# MULTIPLE PLAY MANUAL TURNTABLES

## SERVICE BULLETIN

SUBJECT: NEW CARTRIDGE MOUNTING SCREWS-ALL MODELS

SUBJECT: FAILS TO TRIP

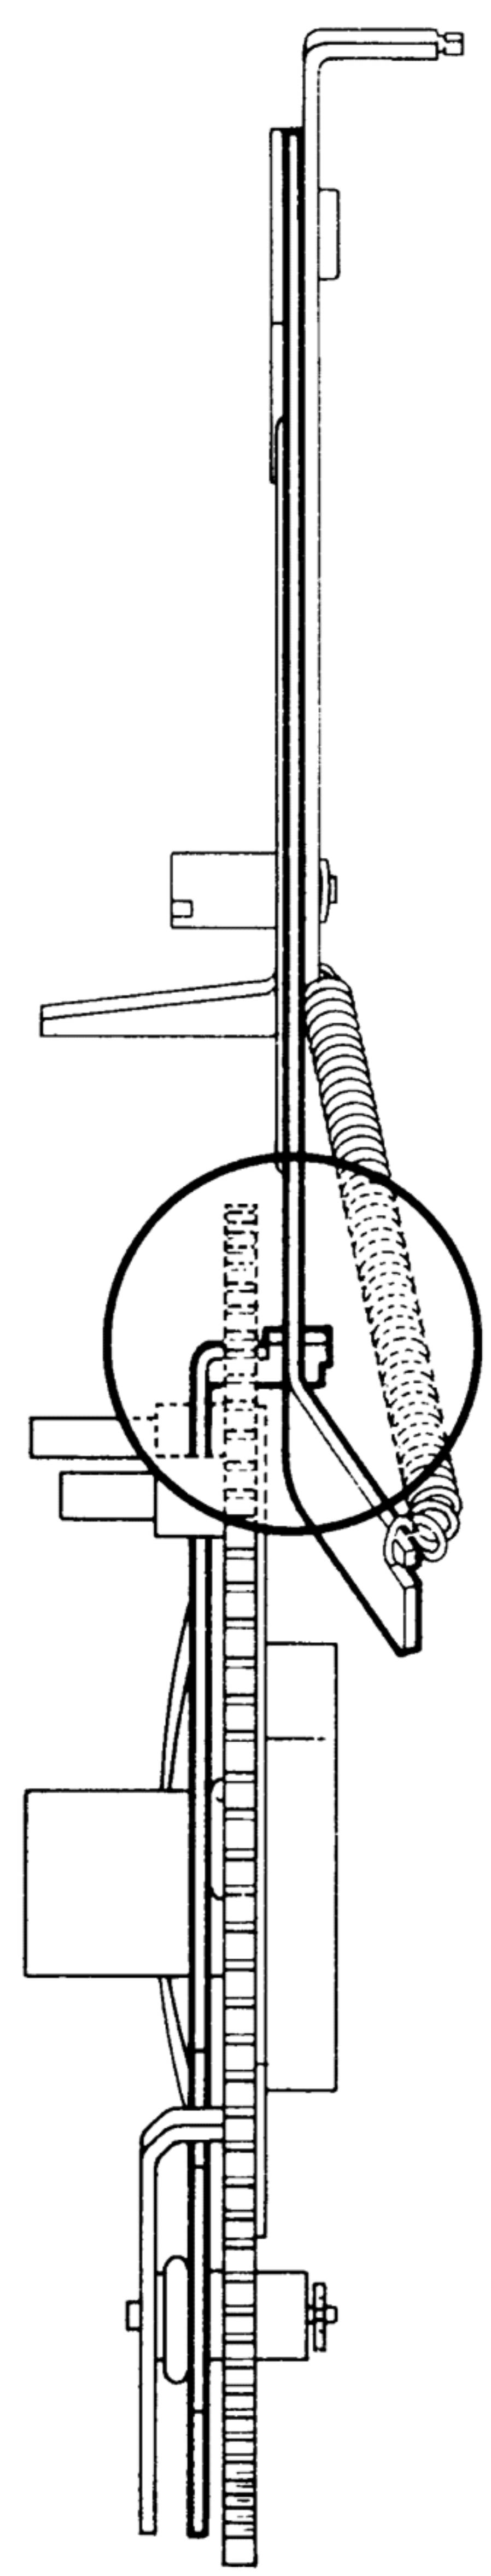
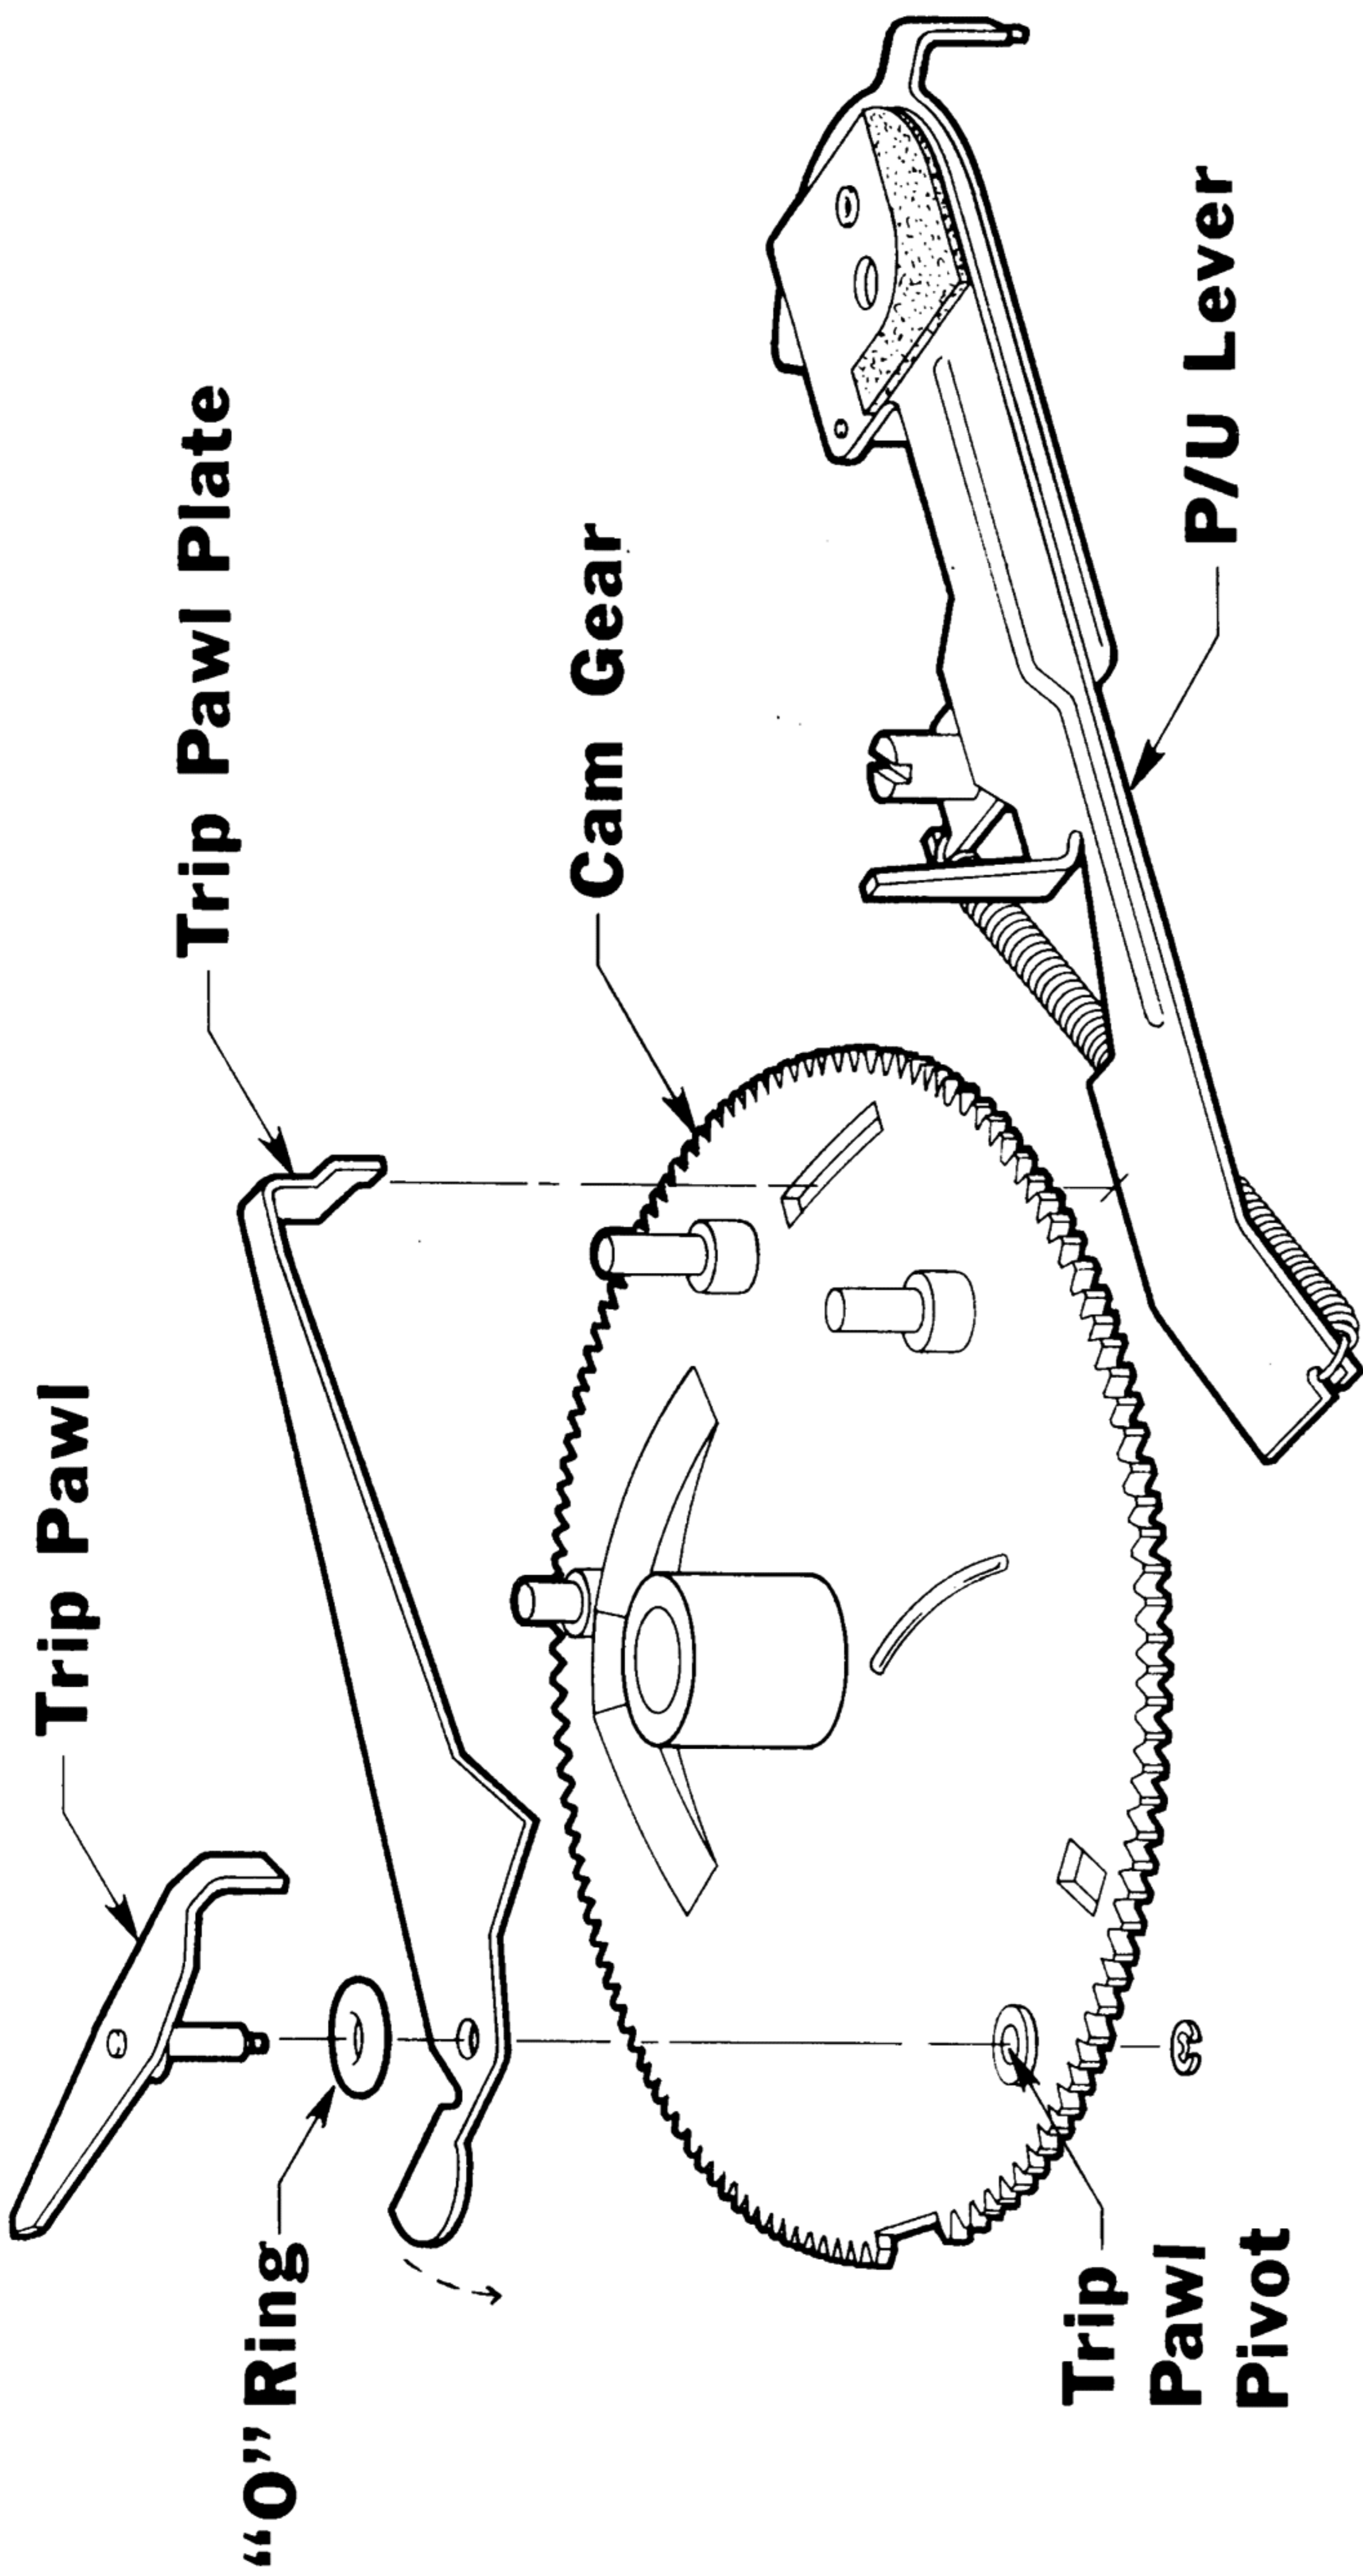
As the tonearm reaches the lead out grooves, the pickup lever begins to impulse the trip pawl plate. The trip pawl "O" ring assembly will move in the same manner. The friction between the trip pawl plate and "O" ring is critical. If the "O" ring is contaminated, a loss of friction between the trip pawl plate and "O" ring may occur.

After a trip is activated, the half moon area on the trip pawl plate (shown near the "O" ring) should extend past the teeth on the main cam gear. Should this not occur, the trip pawl and plate will not reset sufficiently. This will cause a failure to trip condition after the next record has played.

The area of contact between the "O" ring and trip pawl plate should be thoroughly cleaned with alcohol.

The half moon extension can be realigned. Carefully, with a small pair of needle nose pliers, grasp the half moon and pull straight out so that it extends slightly past the cam gear teeth. When examining the trip pawl plate, be certain that it is not pulled too far or bent vertically, as this can cause continuous cycle. Install the platter and cycle the unit. The trip pawl plate will "set" automatically.

MOTOR CONTROL BOARD MODEL 980/1000

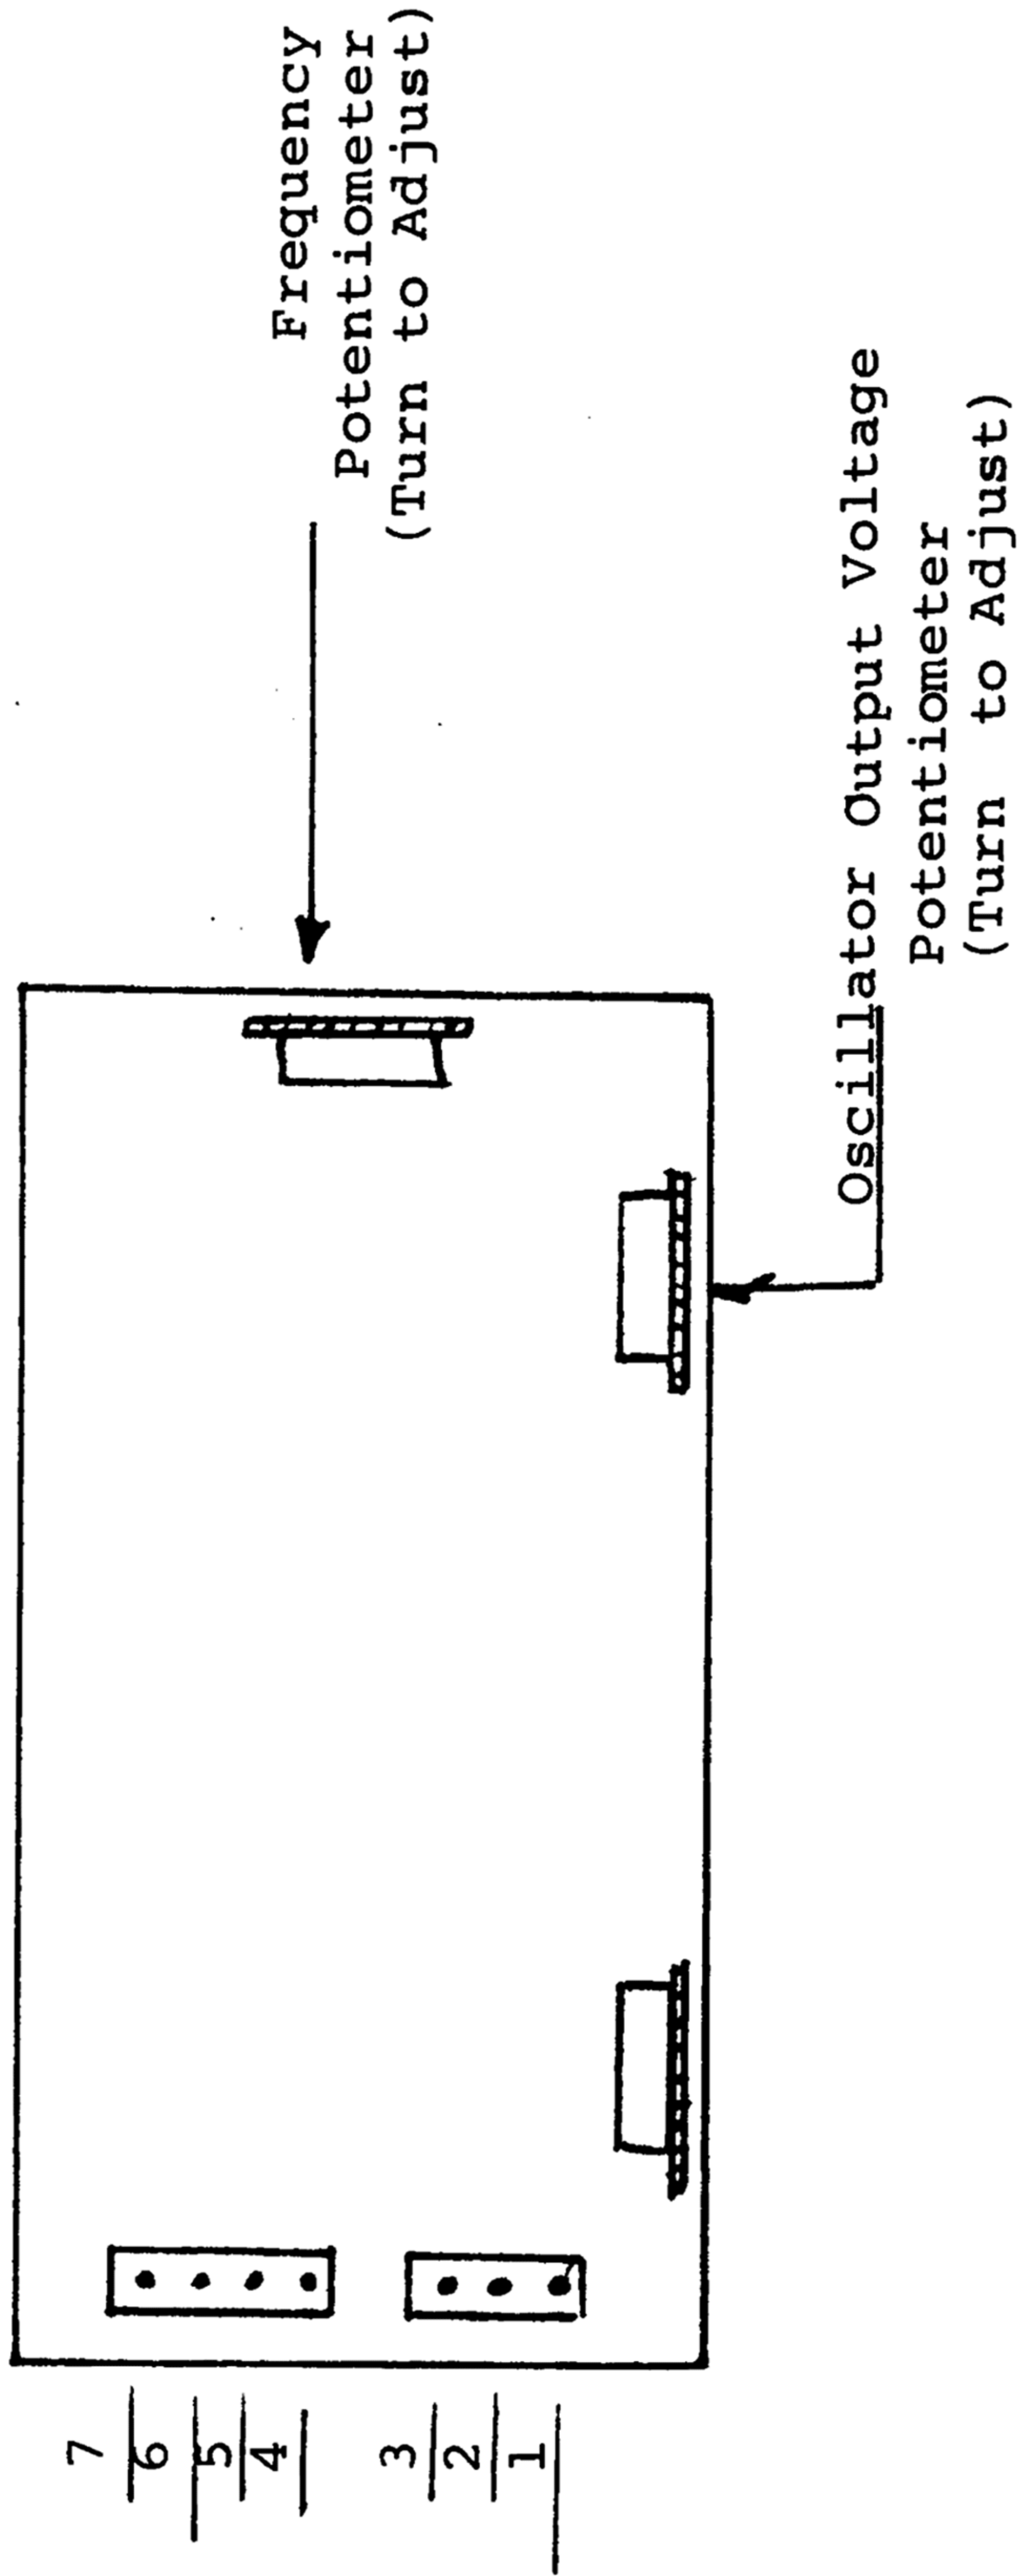
The following is the adjustment procedure for the Wein Bridge motor control electronics on the Model 980 and 1000. Refer to the diagram for location of adjustment and test points.

1. The nominal "warm up" characteristic for this circuitry is ten minutes.
2. Approximately center the "pitch" control knob on the top left corner of the base plate (do not be concerned if the strobe image moves at this time).
3. Adjust the oscillator output voltage potentiometer per motor spec (see diagram). Motors with black and white leads should be adjusted for 5 volts AC; motors with red and black leads for 4 volts AC. Besides lead color, most motors also have the required voltage stamped either on the side or on the top.

- a. Measure and adjust for required voltage between pins 4 and 6.
  - b. Repeat same procedure at pins 5 and 7 and note amount of any difference. If greater than .3 volts, replace P. C. board.
4. Adjust the frequency potentiometer to stabilize strobe image. (See diagram for location)
  5. Due to interaction with Step No. 4, repeat Step No. 3 until both are within spec.
